# Fire Risk Assessment

## **33 Provost Street**

Version 3

29 August 2023

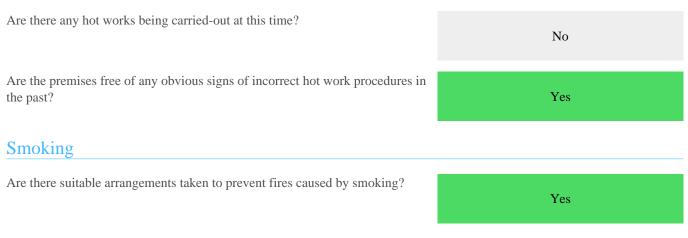
There was an excessive amount of combustible items in the corridor outside flats 2 and 3.

Source Version	1
Category	Fire Prevention
Sub Category	Housekeeping
Action Required	The storage of combustible items in communal areas is excessive and should be reduced.
	3rd floor lobby (flats 2 and 3).
Priority	Medium
Status	Identified
Owner	Neighbourhood Services
Due Date	3 September 2020

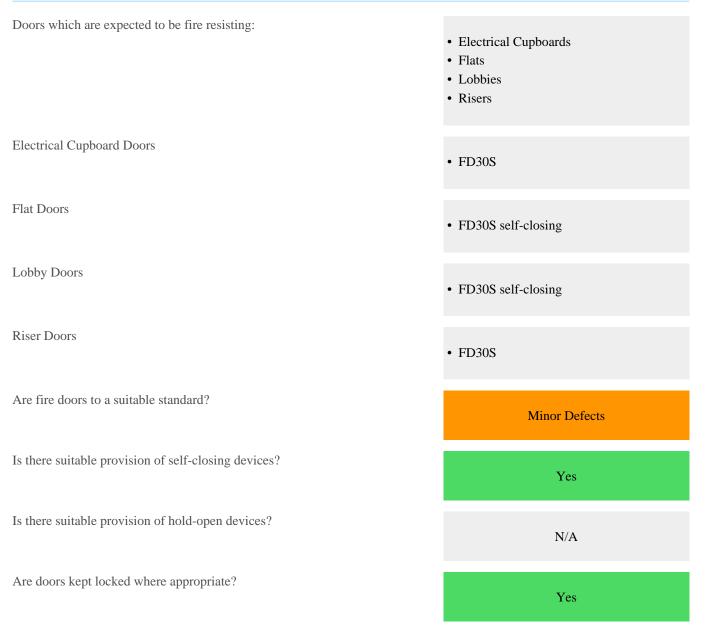
There are electrical cables in common areas which are suspended in uPVC conduit. requirement introduced in 2015 in BS 7671 which covers electrical installations in the UK, states that all new wiring systems are to use metal, rather than plastic, to support cables in escape routes, to prevent their premature collapse in the event of a fire.

Source Version	1
Category	Escape Routes & Fire Spread
Sub Category	Ease of Use
Action Required	There are electrical cables in common areas which are suspended in uPVC conduit. requirement introduced in 2015 in BS 7671 which covers electrical installations in the UK, states that all new wiring systems are to use metal, rather than plastic, to support cables in escape routes, to prevent their premature collapse in the event of a fire.
Priority	Advisory
Status	Identified
Owner	Customer Homes
Due Date	5 March 2022

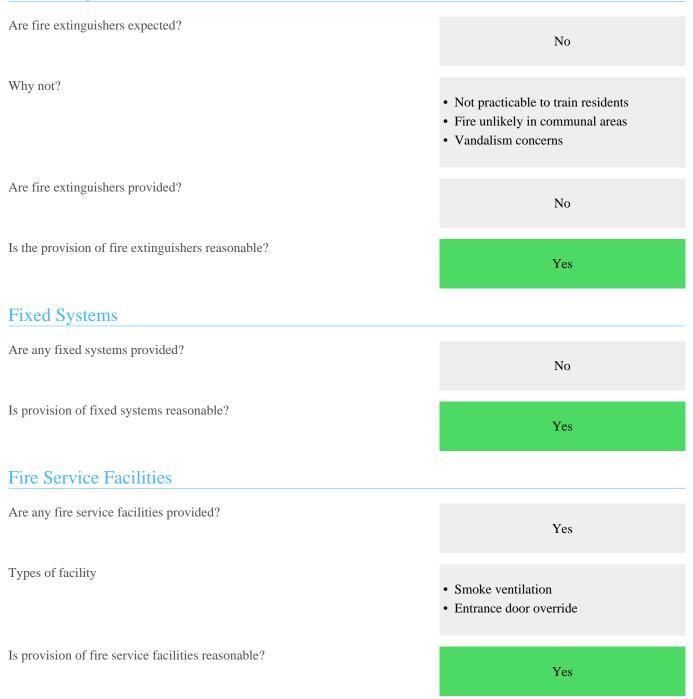
The fire detection system provided for the actuation of the smoke ventilation system appears to be quite dated, with detectors appearing old and in a state of ill repair. Consideration should be given to upgrading or replacing the system.

Source Version	1
Category	Detection & Warning
Sub Category	Automatic Fire Detection
Action Required	The fire detection system provided for the actuation of the smoke ventilation system appears to be quite dated, with detectors appearing old and in a state of ill repair. Consideration should be given to upgrading or replacing the system.
Priority	High
Status	Identified
Owner	Customer Homes
Due Date	3 June 2020
